SUPPLEMENT NO. 1

PHILIP R SMITH ELEMENTARY SCHOOL
GILBANE JOB NO. J07896.000
STATE PROJECT NO. 132-0089N

PRS-SI-0007

Owner Room Names and Signage

PARTIAL FIRST FLOOR CEILING PLAN - WEST
1/8" = 1'-0"

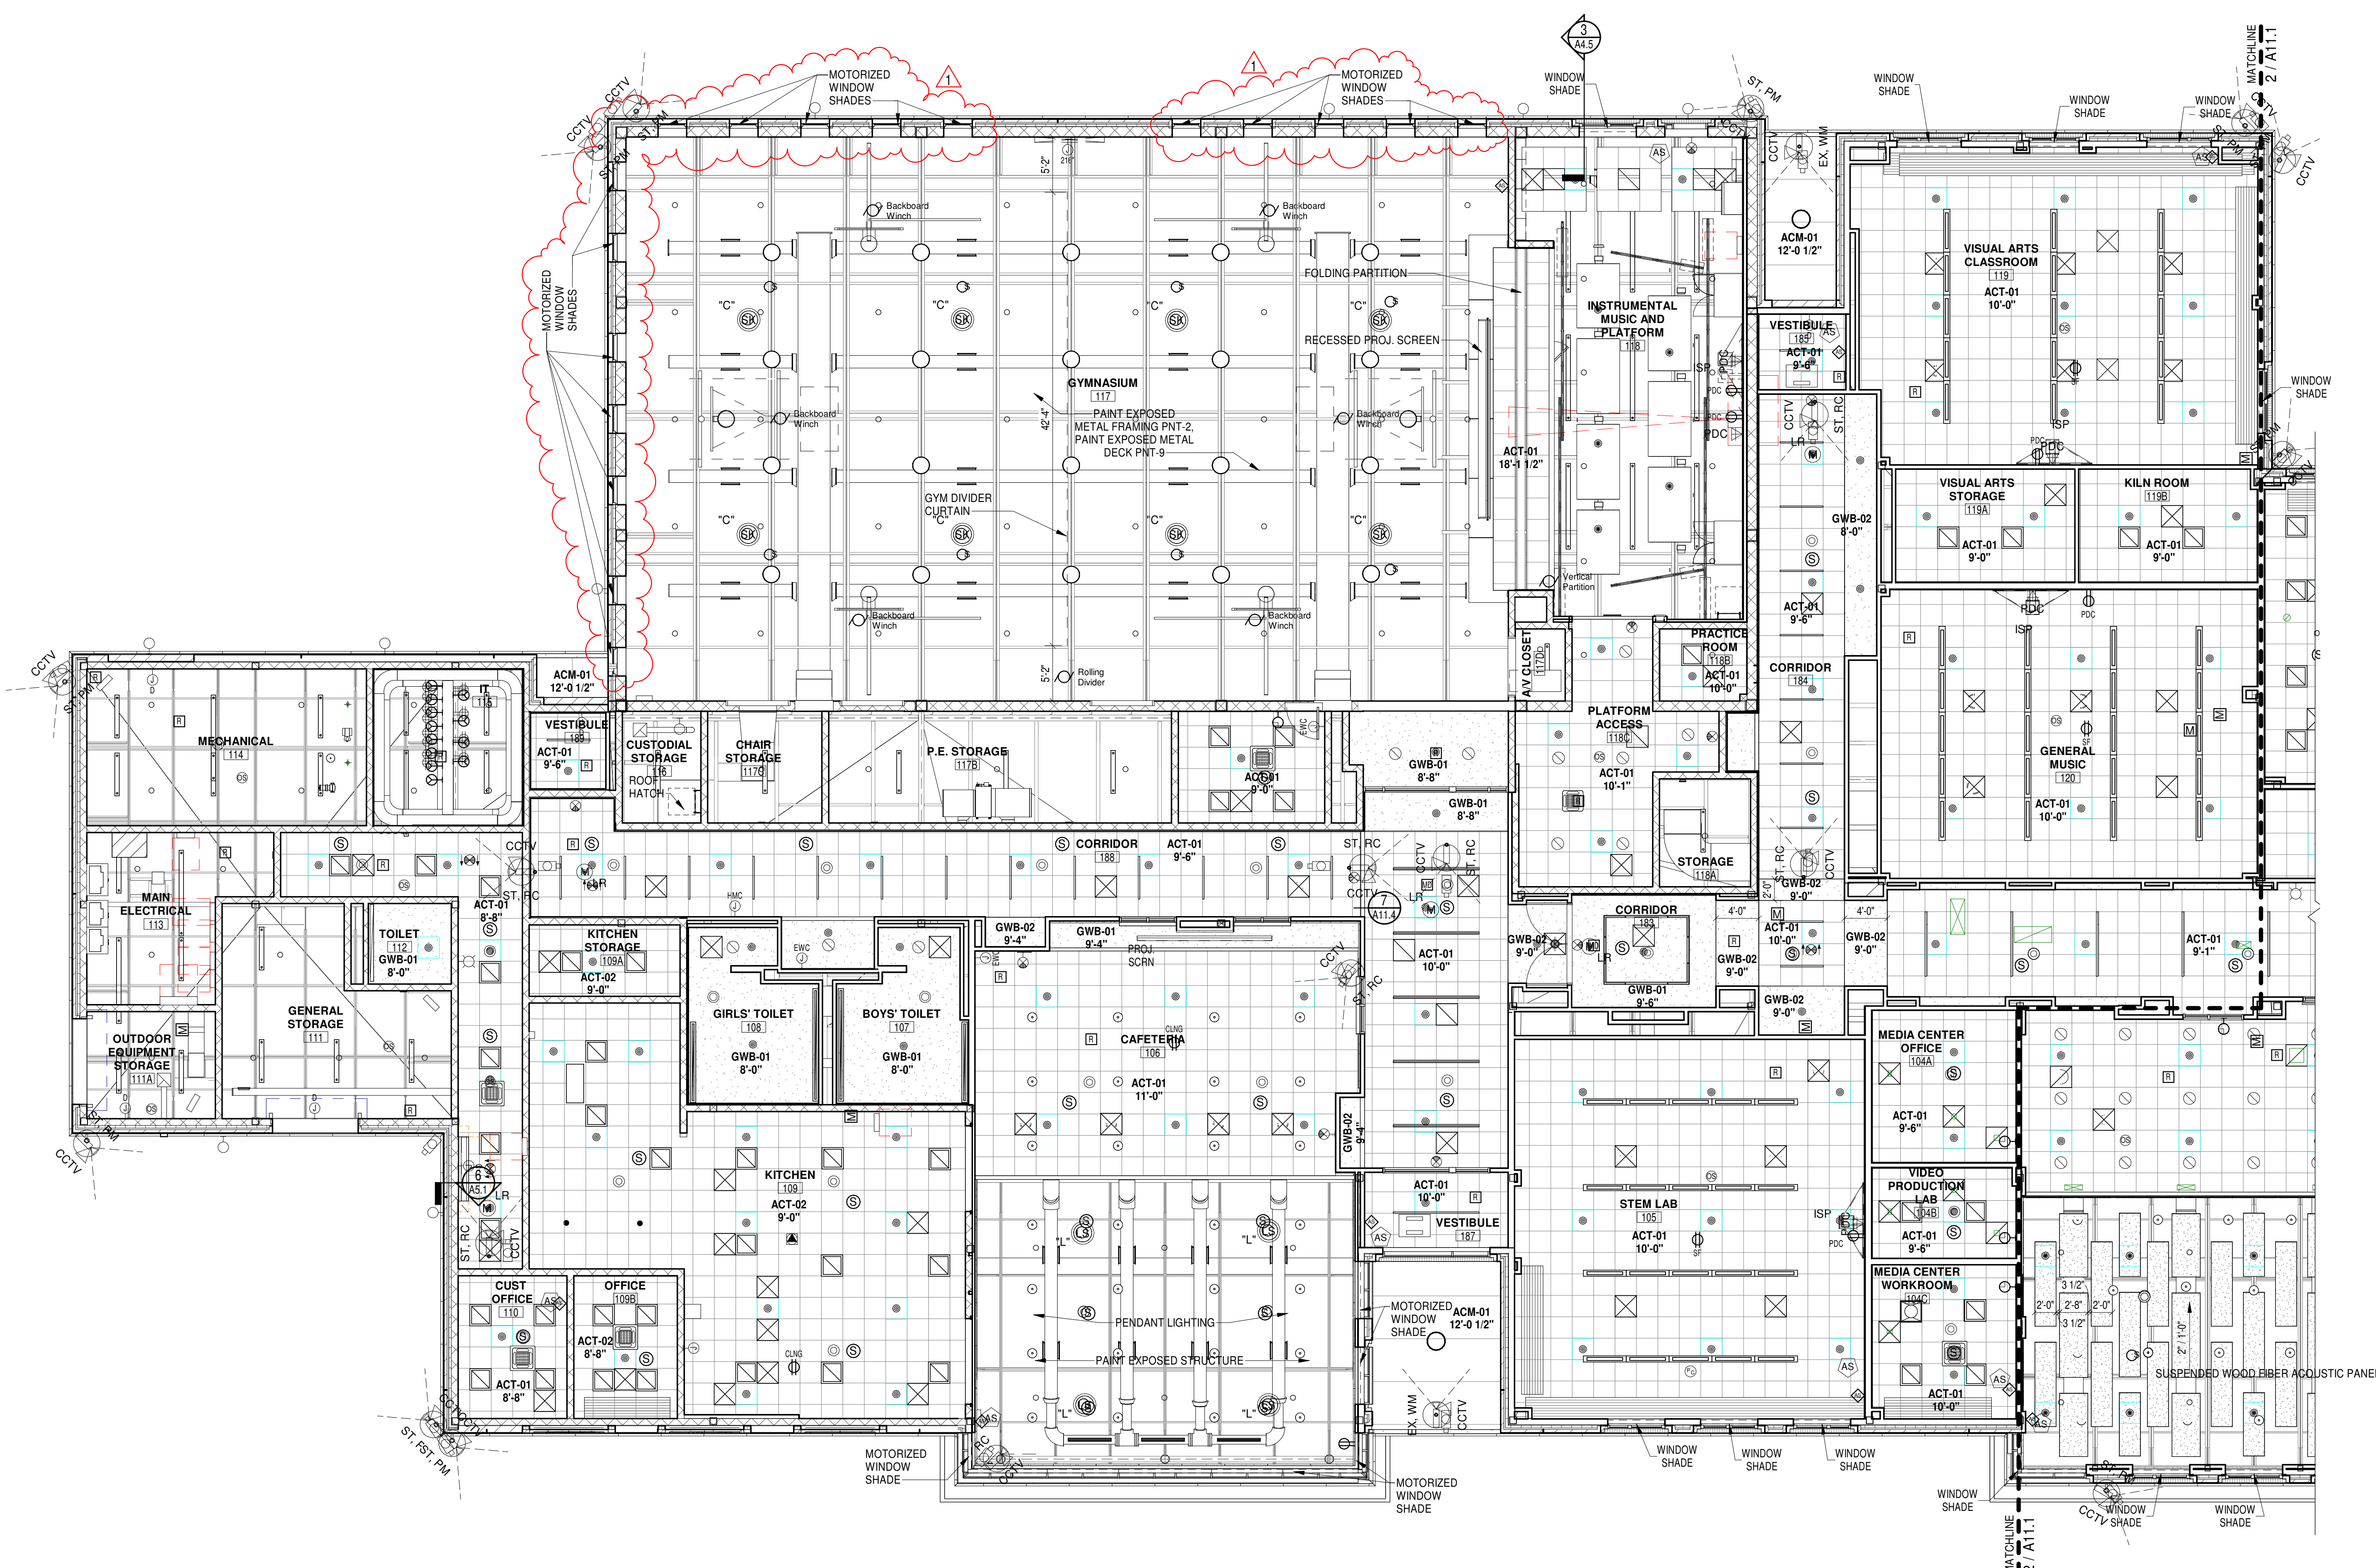
DRAWING A11.2 - PARTIAL FIRST FLOOR CEILING PLAN - WEST: **REMOVE** drawing as Issued for Bids and **REPLACE** with drawing attached to this Addendum with the following revisions:

A1.1

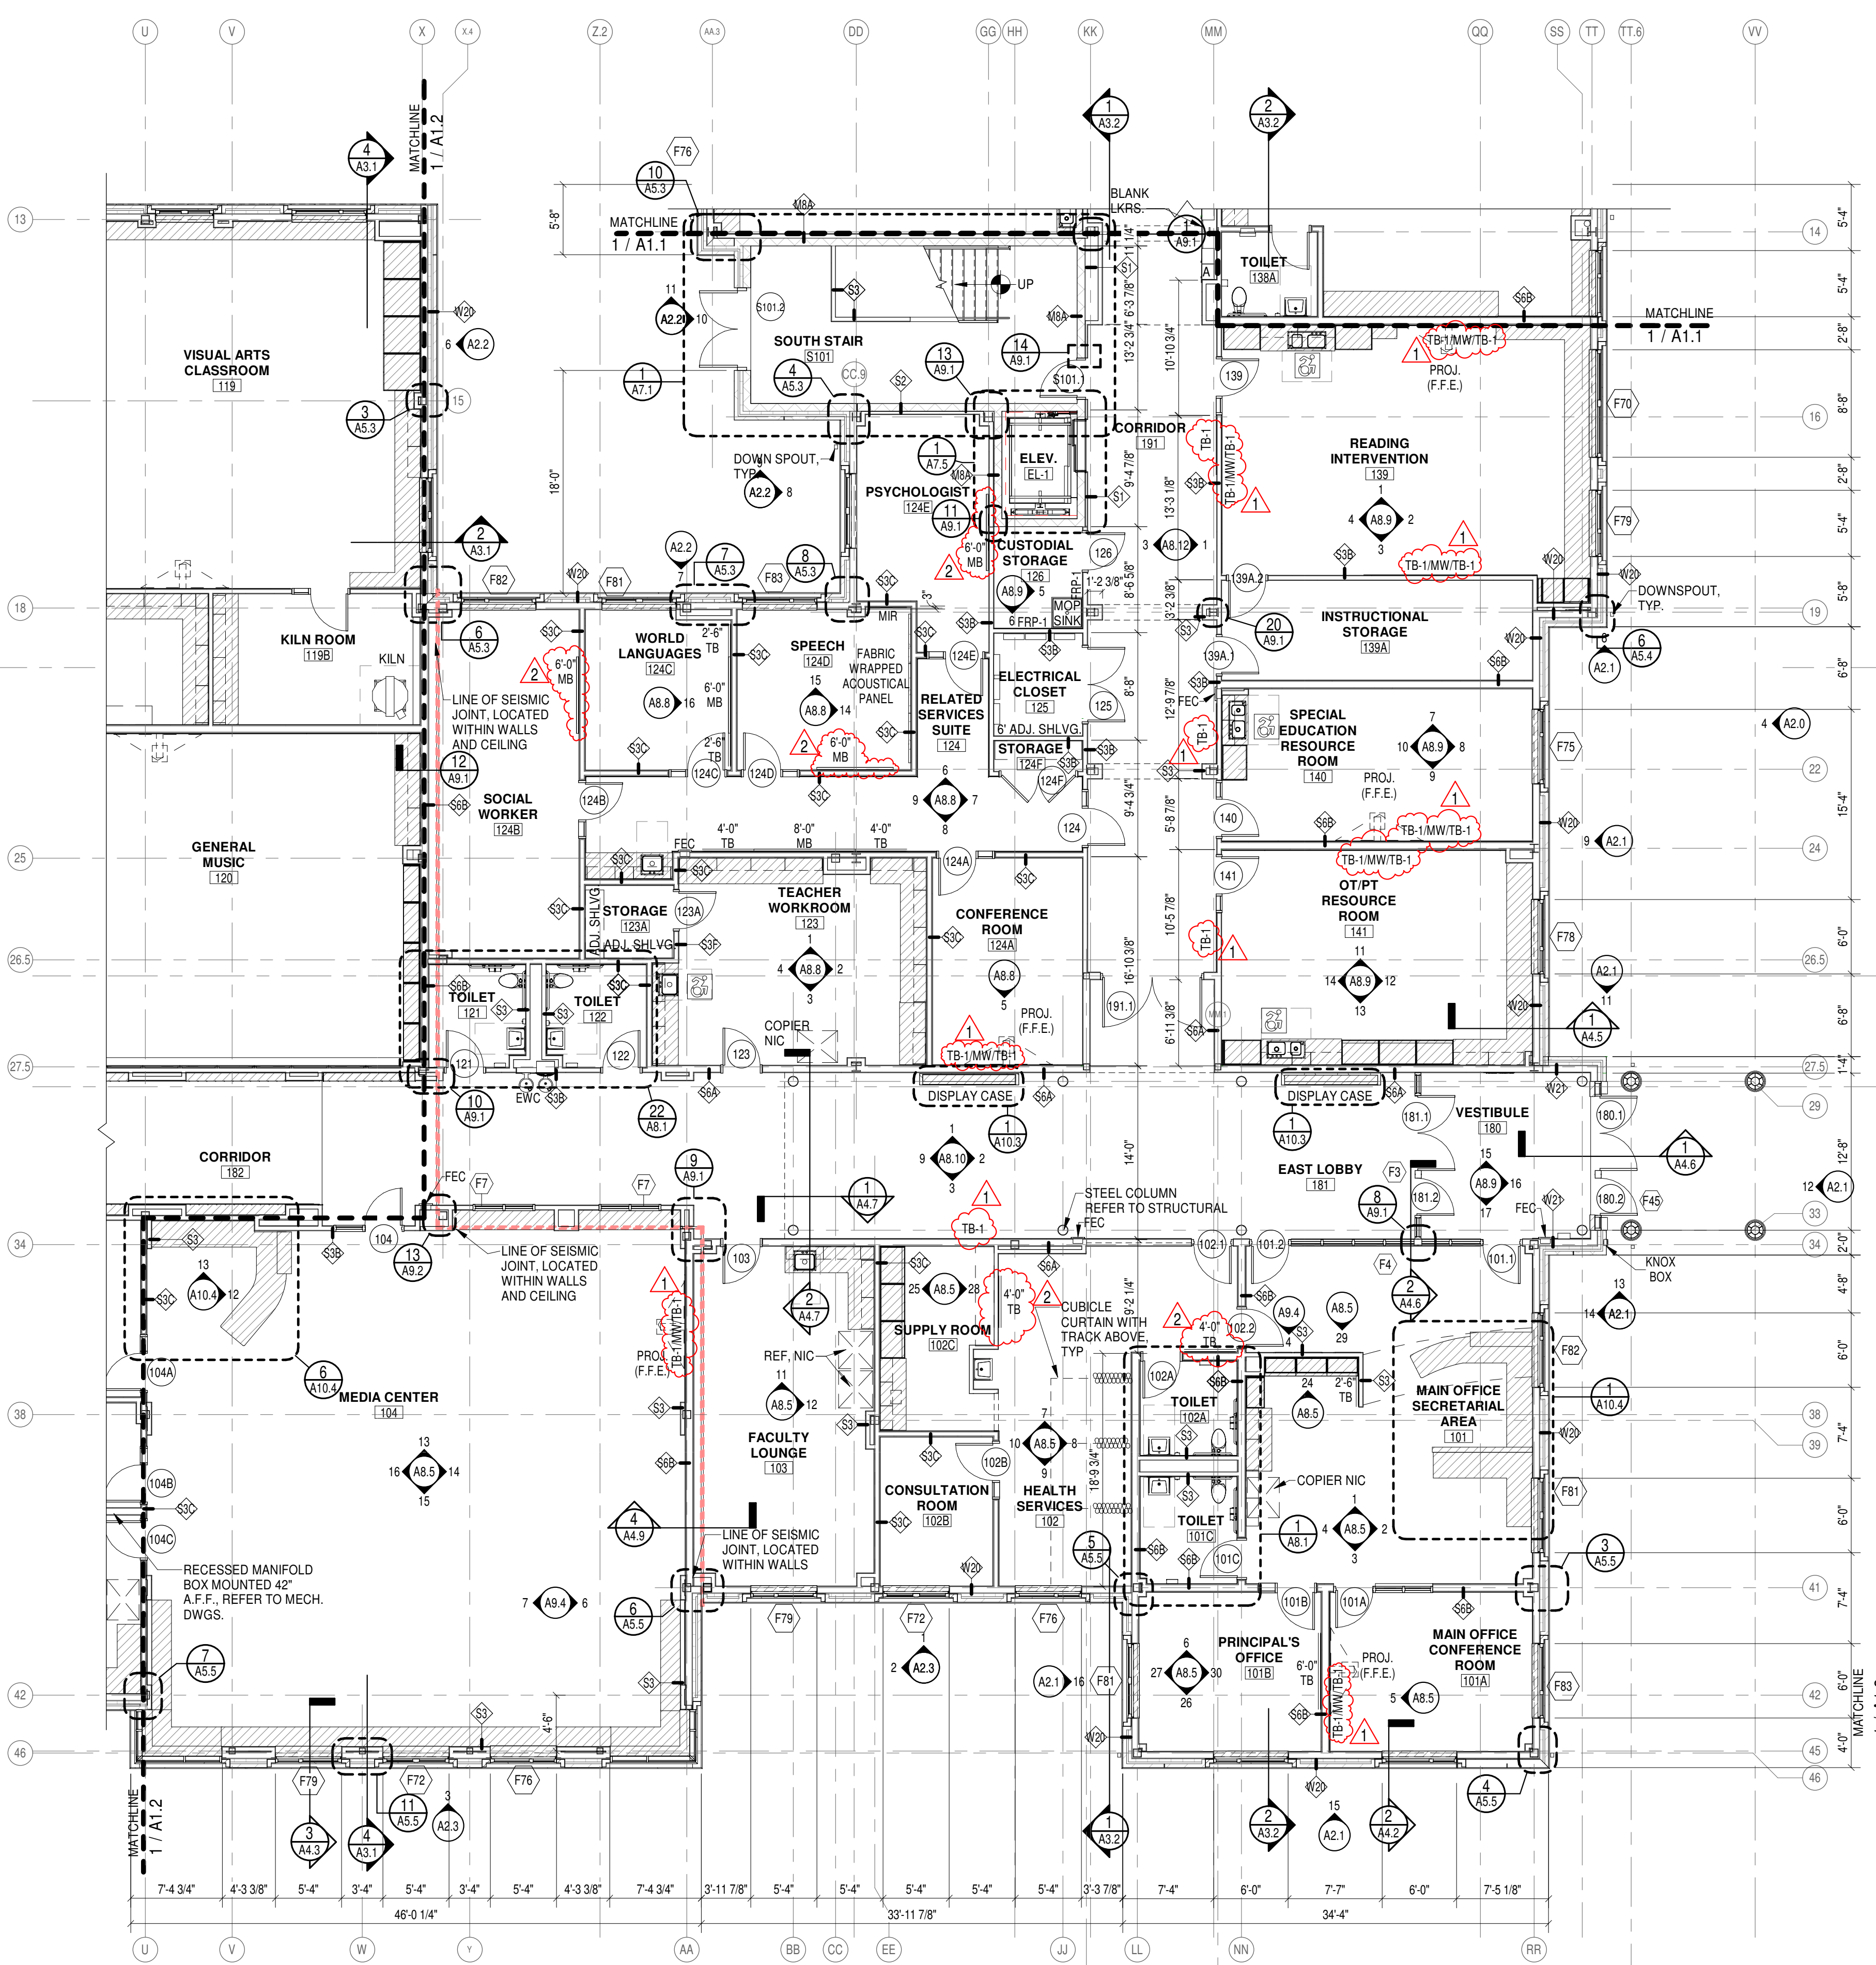
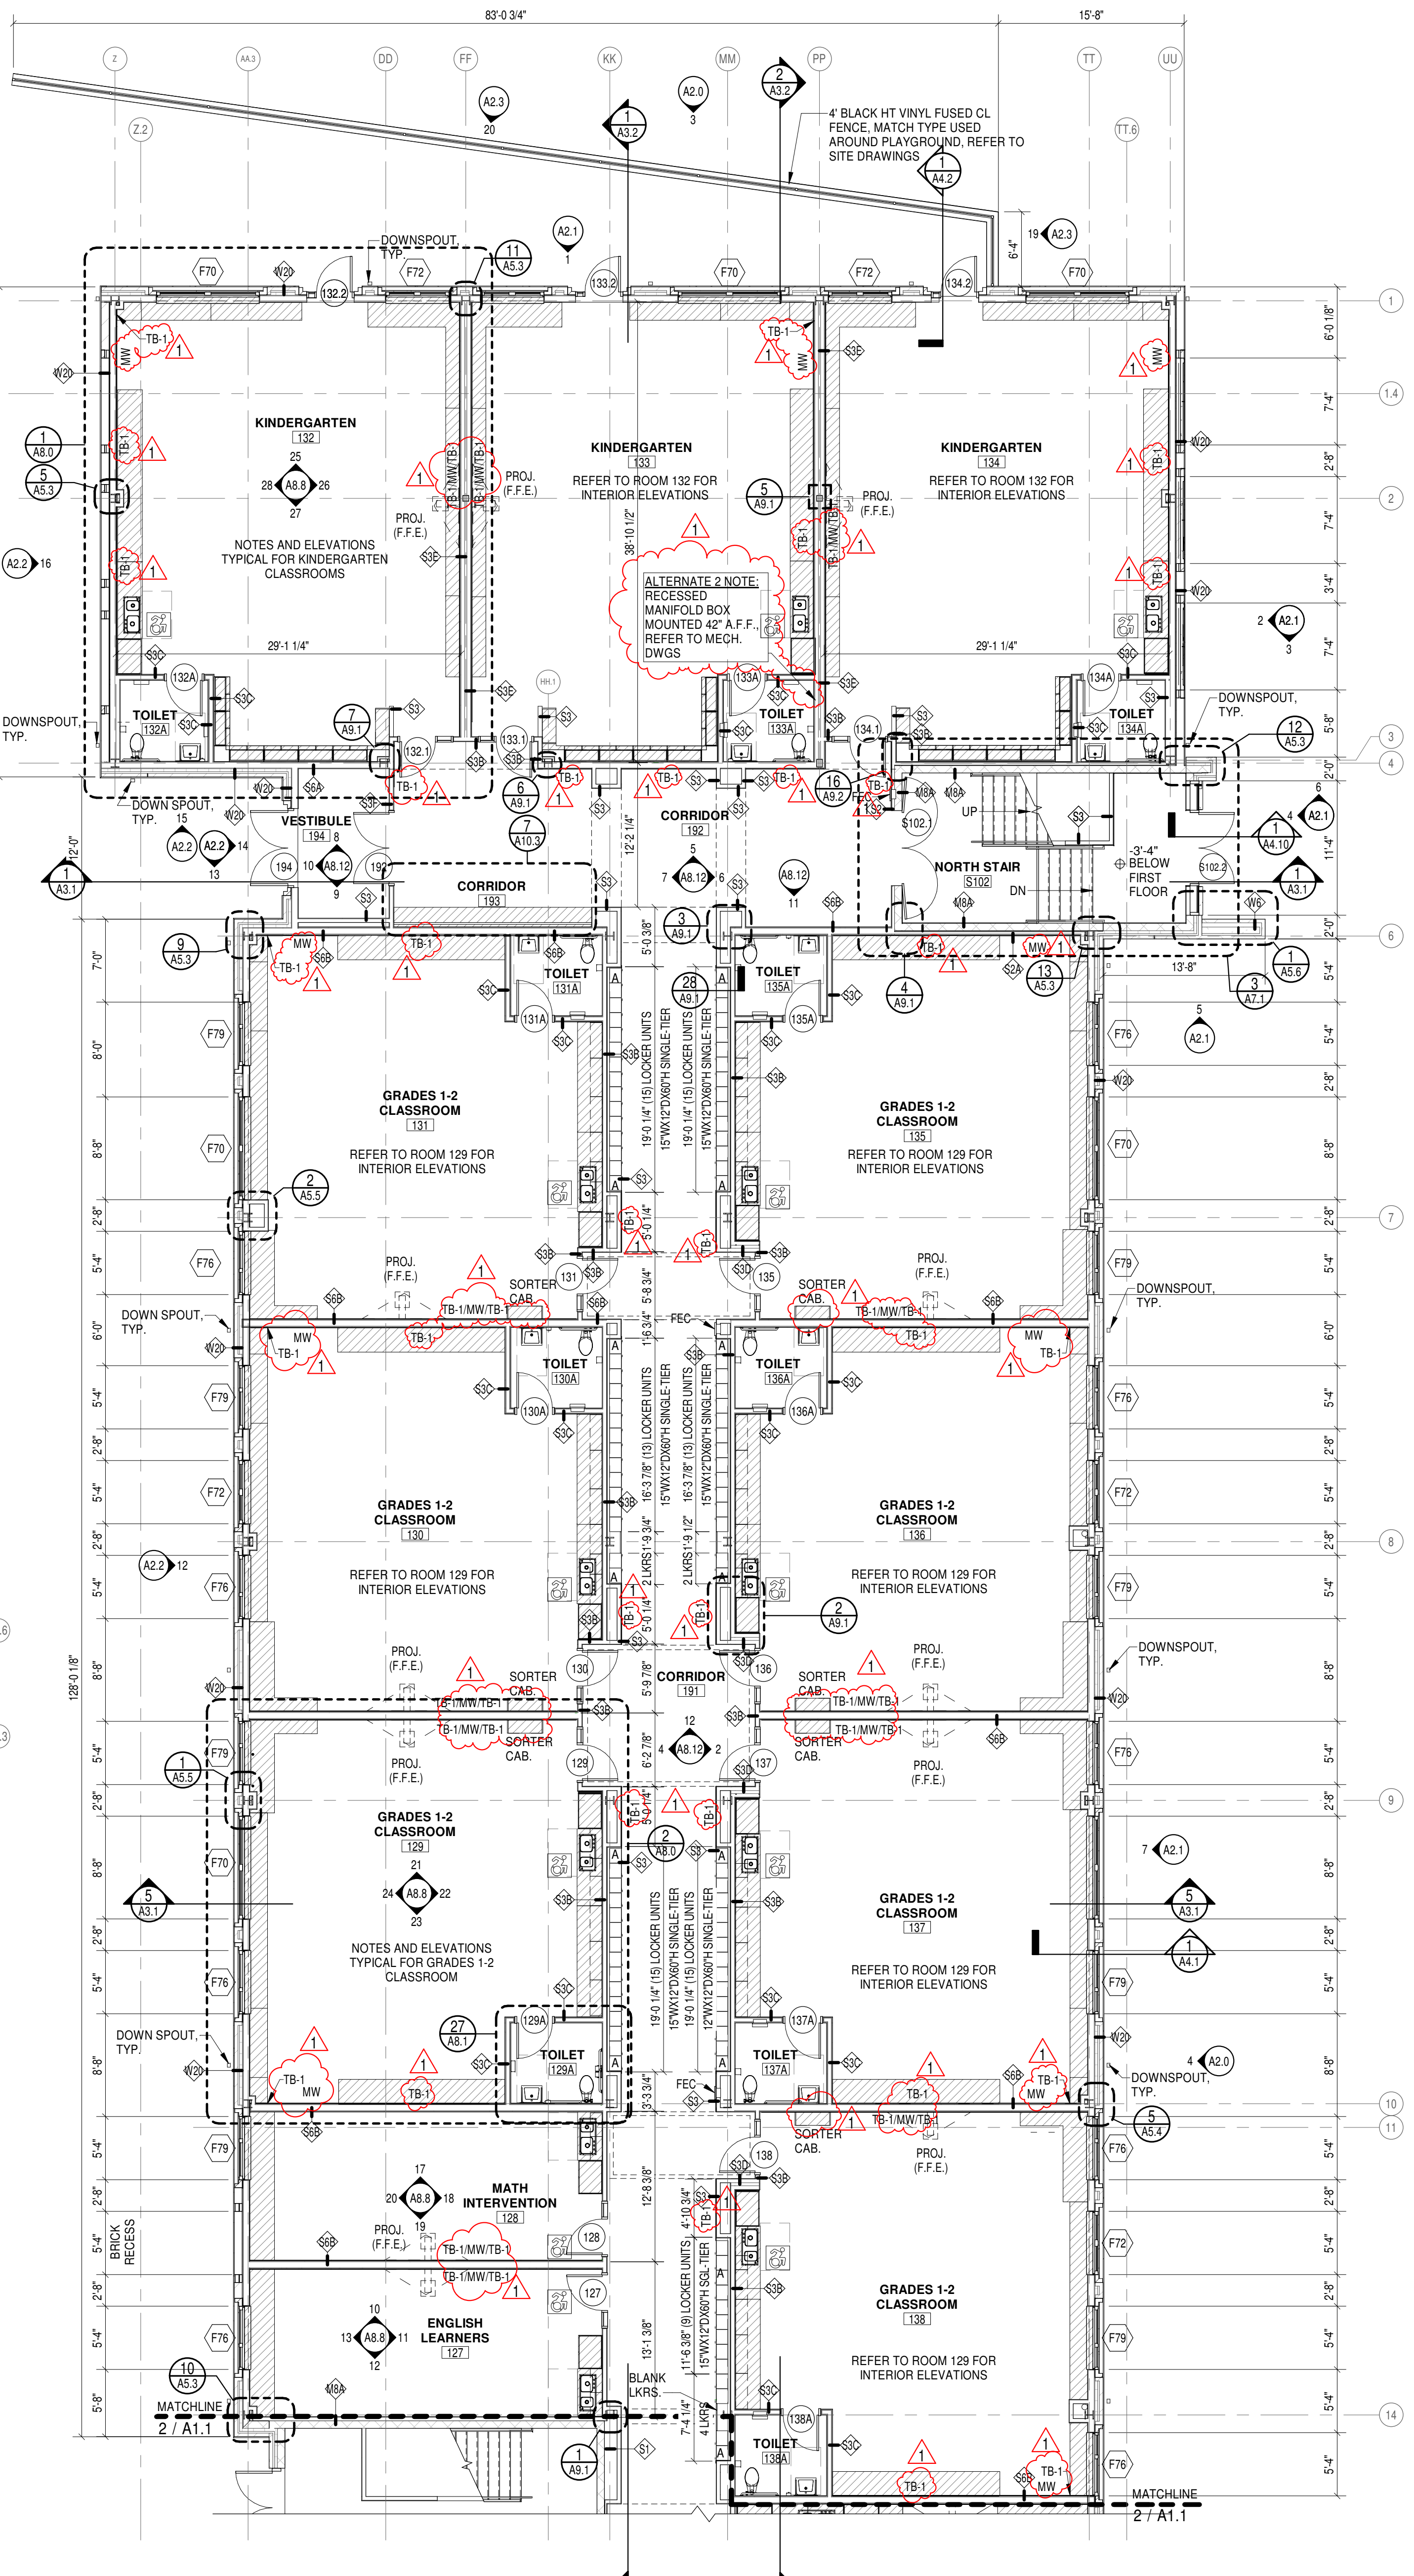
DRAWING A1.1 – PARTIAL FIRST FLOOR CONSTRUCTION PLAN – NORTH AND SOUTH:
ADD Tackboards and Markerboards as follows:
